City of Portland  
Development Review Application  
Planning Division Transmittal Form

Application Number: 2013-058      Application Date: 02/27/2013  
CBL: 431 M006001      Application Type: Level III Site Plan 50,000 - 100,000  
Project Name: Veranda St. Subdivision  
Address: 120 Veranda Street  
Project Description: Subdivision of 2 lots into 3 lots.  
Zoning: R5

**MEMORANDUM**

**Subject:** Application ID: 2013-058

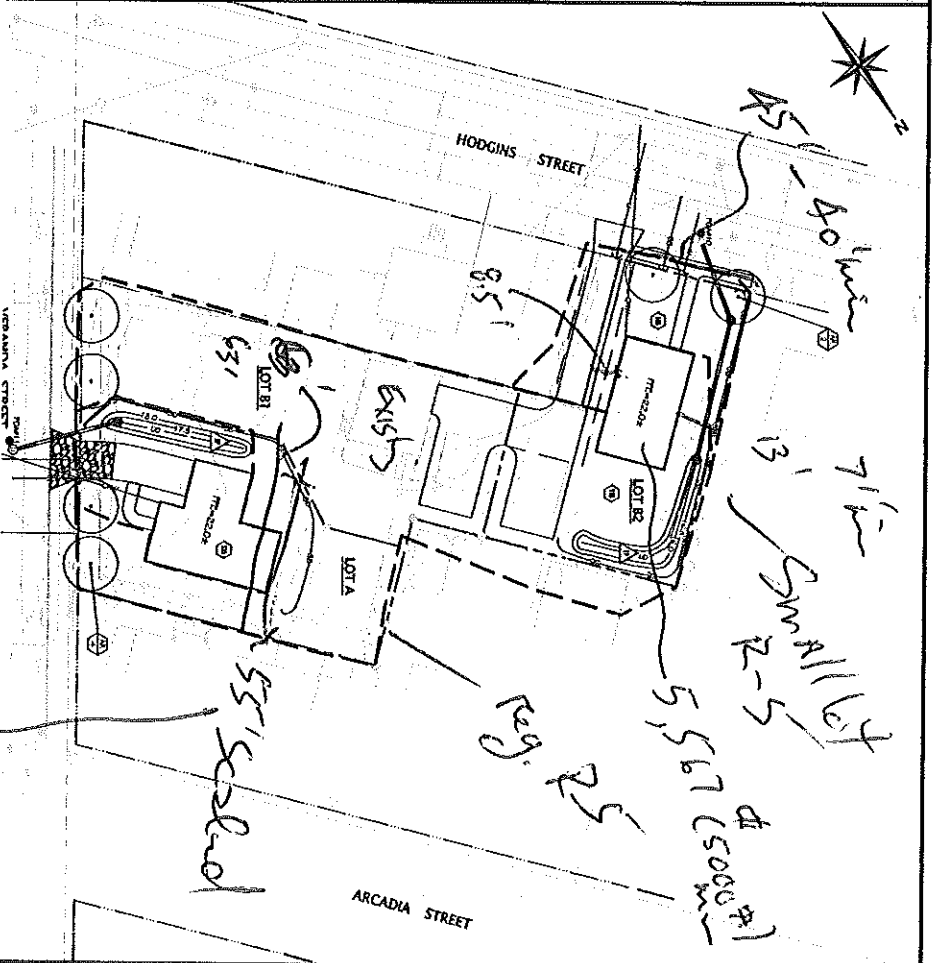
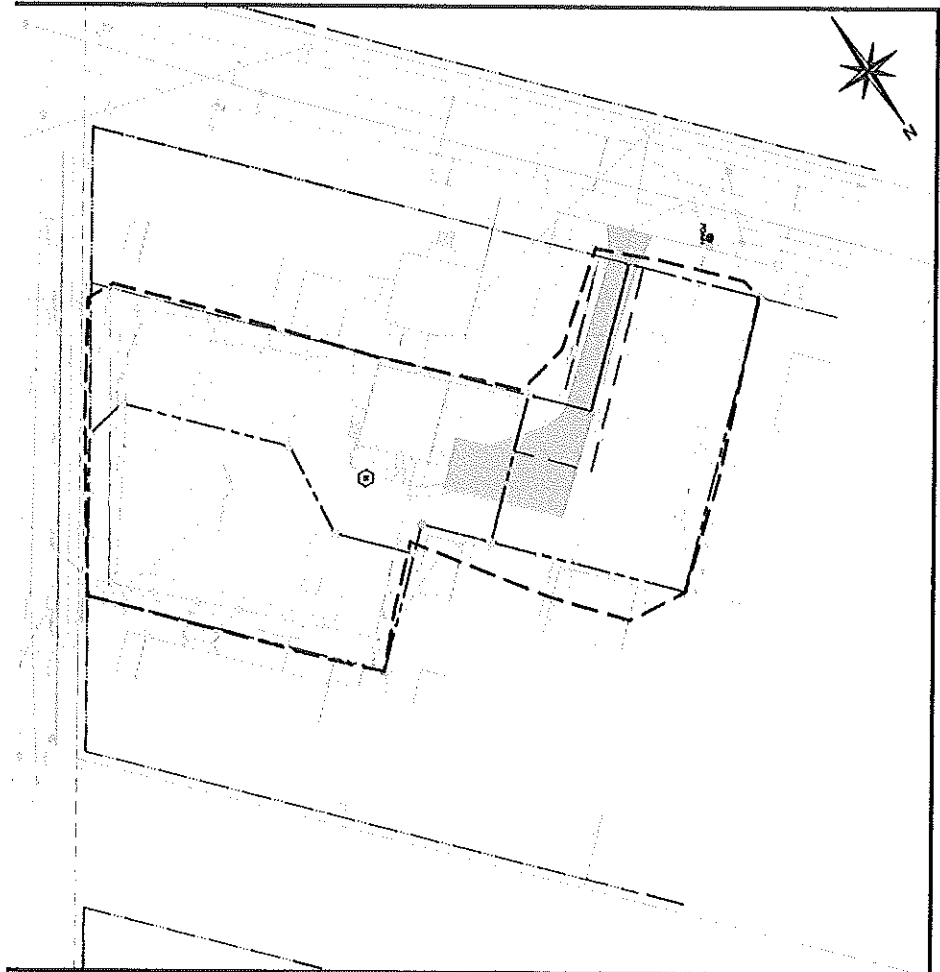
- \*
4. *On Lot "A" where the generic building is placed, violates the regular R-5 minimum lot width requirement. The regular R-5 zone requirements state there shall be a minimum of 60 foot for a lot width where a building is placed on a lot. The sketch should be revised to show that all regular R-5 zone requirements can be met. This will help eliminate any misunderstandings from a future purchaser of the land who will want to build on the lot and assume a building can be placed where it cannot.*

60' min lot width

Response: We have revised the generic building footprint to show it meets all regular R-5 Zone requirements.
